Request for Additional Information No. 532, Supplement 3

U. S. EPR Standard Design Certification

SRP Section: 19 - Probabilistic Risk Assessment and Severe Accident Evaluation

QUESTIONS for PRA Licensing, Operations Support and Maintenance Branch 1

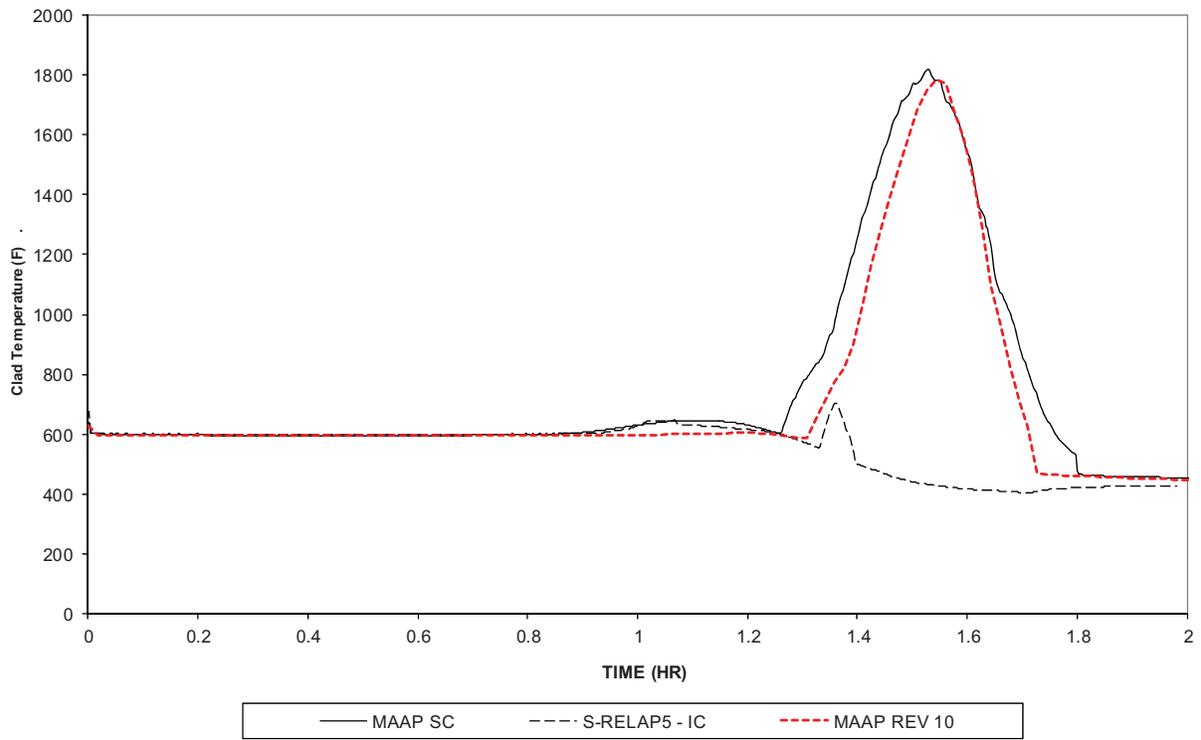
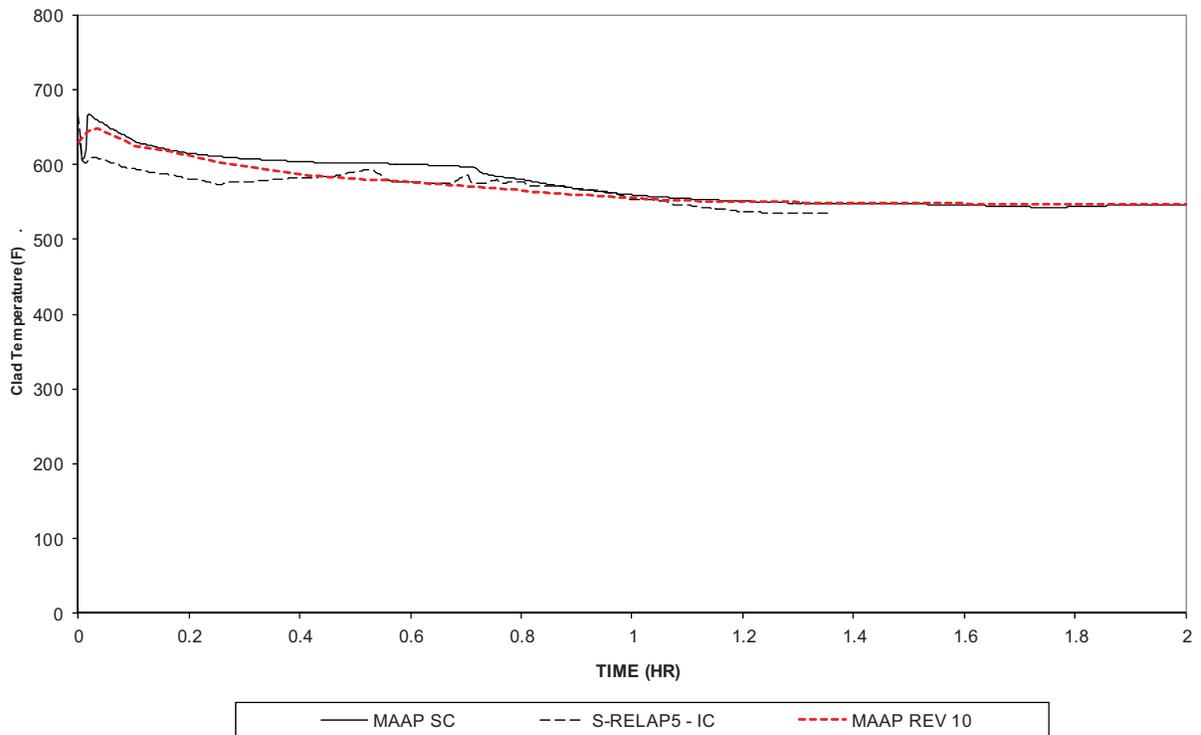
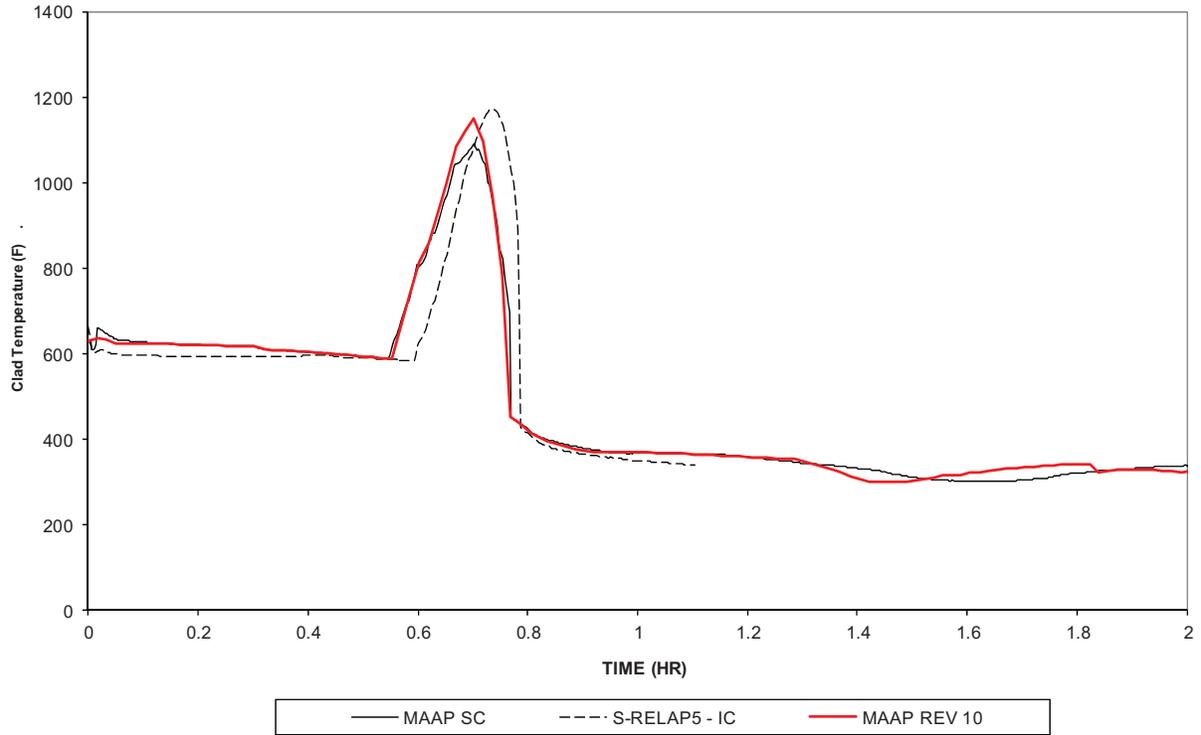
1. Provide summaries of all changes in the MAAP input model, including
 - a. Nodalization
 - b. Geometrical input
 - c. Error correction
 - d. Implication of changes (including correction of errors)
2. Provide a summary of the phenomenological modeling differences between MAAP 4.0.7 and 4.0.6 and their impact on in-vessel accident progression with emphasis on MAAP-based specifications for analysis of various PRA and severe accident issues (e.g., ex-vessel steam explosions, hydrogen generation and distribution in containment, etc.)
3. Indicate which nodalization, coarse or fine, will be the basis for the new results provided in the FSAR.

These same five cases have been re-analyzed with the most recent version of the U.S. EPR MAAP4 parameter files. The results for the peak cladding temperature are presented below in Figure 19-352-1 through Figure 19-352-5. It should be noted that “MAAP SC” refers to the original benchmark case, “MAAP REV 10” refers to the calculation using the most recent parameter file, and the “S-RELAP5-IC” refers to the S-RELAP data that the case is benchmarked against.

Based on Figure 19-352-1 through Figure 19-352-5, the resulting peak cladding temperatures were found and are presented in Table 19-352-12 below.

In conclusion, the enhancements made to the U.S. EPR MAAP4 parameter file do not adversely change the conclusions that were made in the previous Level 1 PRA benchmark calculation.
